MILITARY SPECIFICATION

TRANSMITTERS, PRESSURE, HELICOPTER, VOLTAGE RATIO TYPE, GENERAL SPECIFICATION FOR

This amendment forms a part of MIL-T-58097(AV) dated 10 January 1975 and NOTICE 2, dated 19 January 1990, and is approved for use by all Departments and Agencies of the Department of Defense.

FIGURE 1. TRANSMITTER CASE

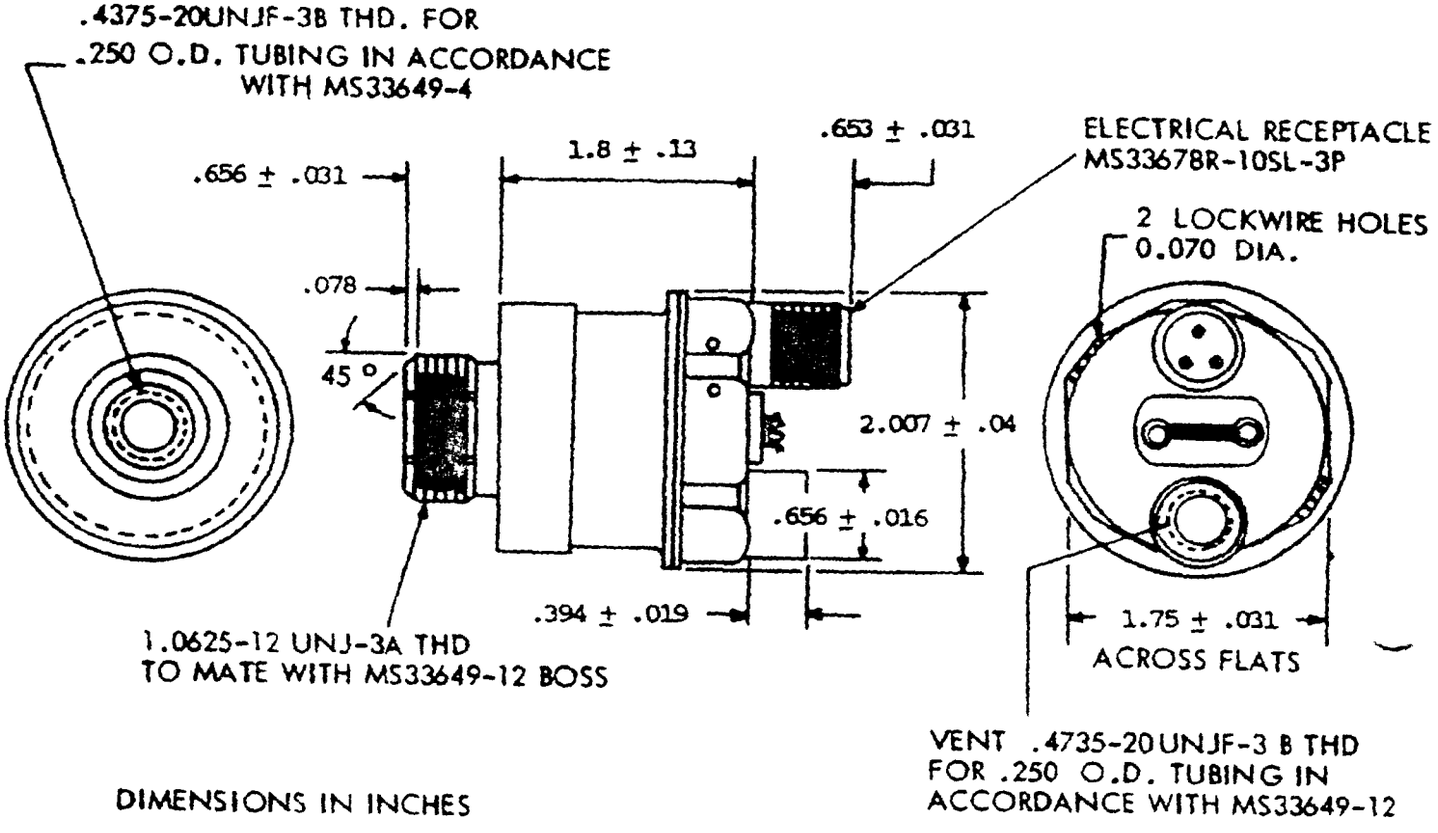
Replace FIGURE 1. TRANSMITTER CASE, with the following figure.
